# SUBSURFACE WASTEWATER DISPOSAL SYSTEM APPLICATION

AUGUSTA PERMIT # 751 TOWN COPY

## SUBSURFACE WASTEWATER DISPOSAL PLAN

# Replacement System Variance Request

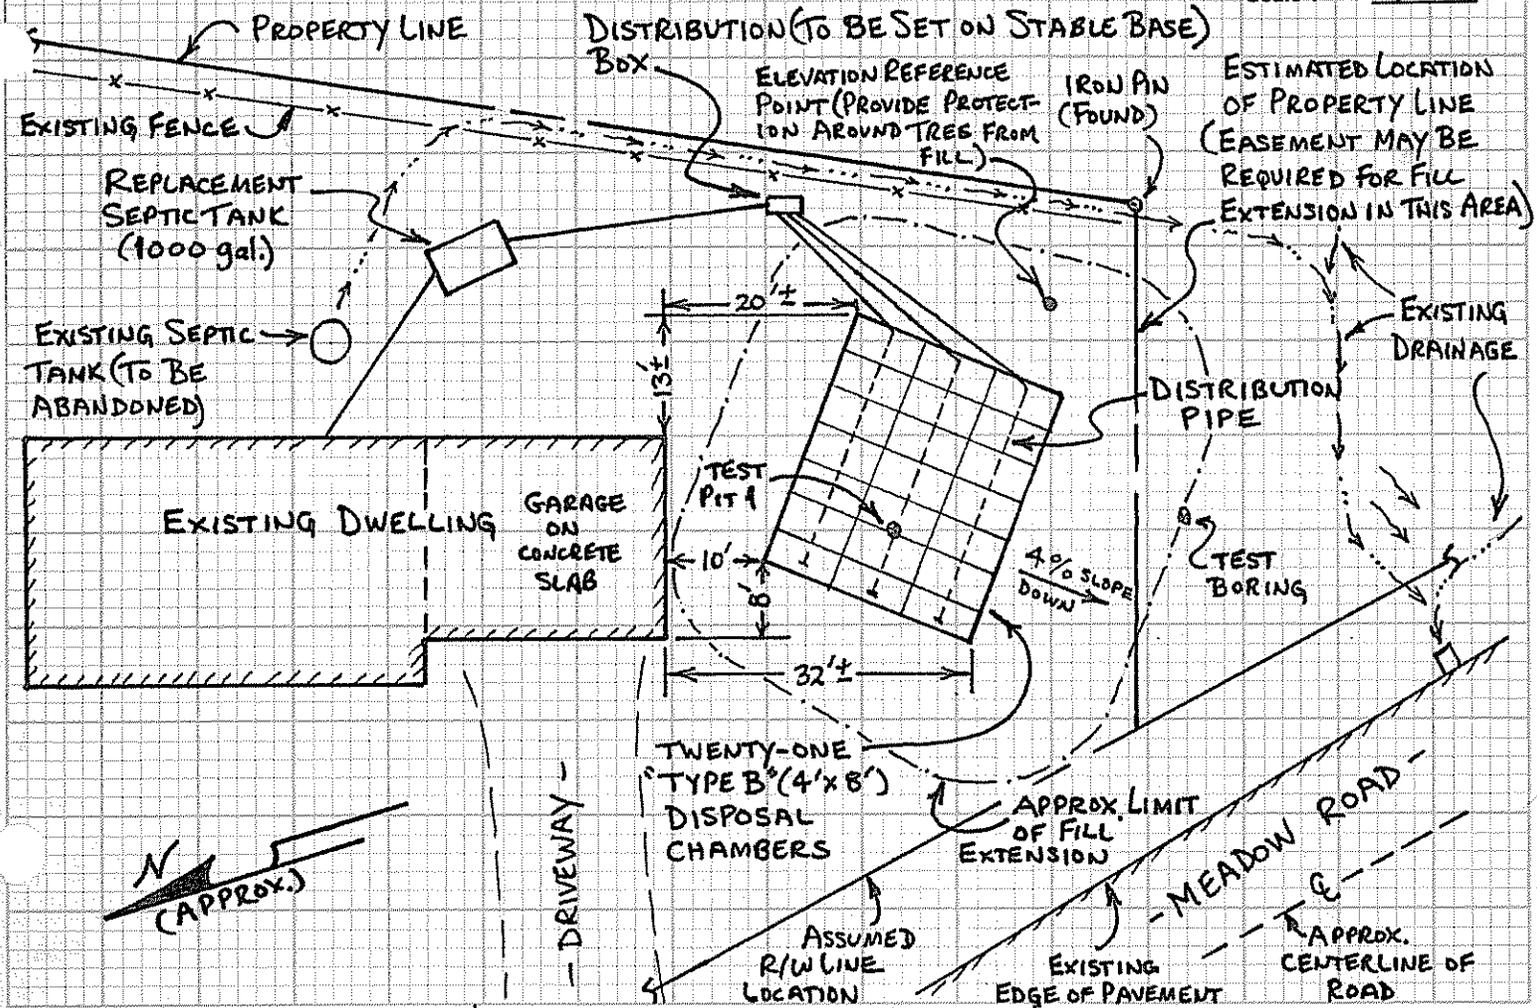
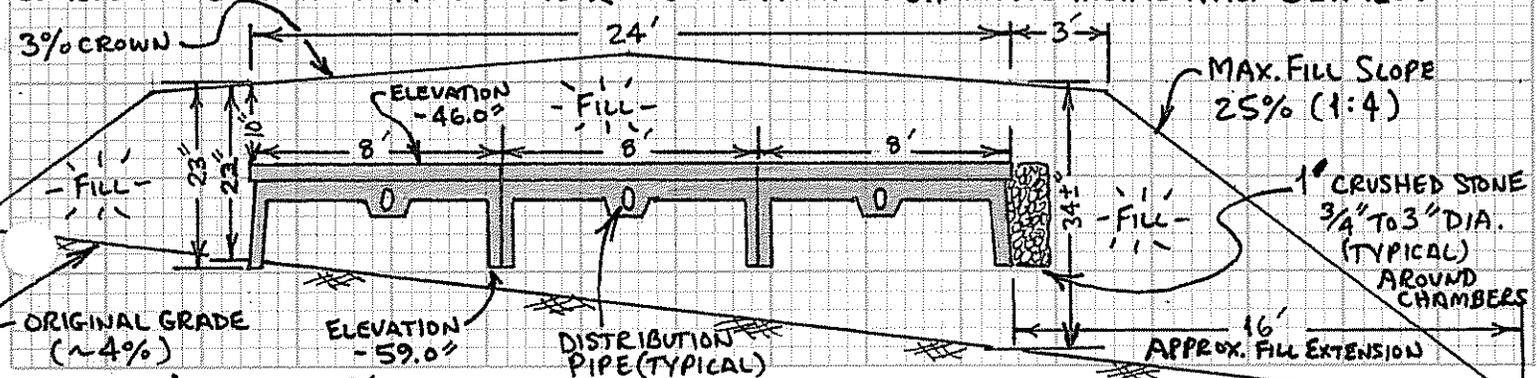
7-11-14 These chambers were installed over the  
root system of a willow tree. I explained the  
city and state concerns to Mr. Knapp & Verduine  
stated that the roots and tree should be  
removed before installing this system as is.  
Willow trees will usually root on the surface  
and play a system after they usually  
fall with high winds and lift a lot  
of surrounding ground which in this case  
would damage the radiator system. At this  
time they have chosen to leave the roots  
and tree.
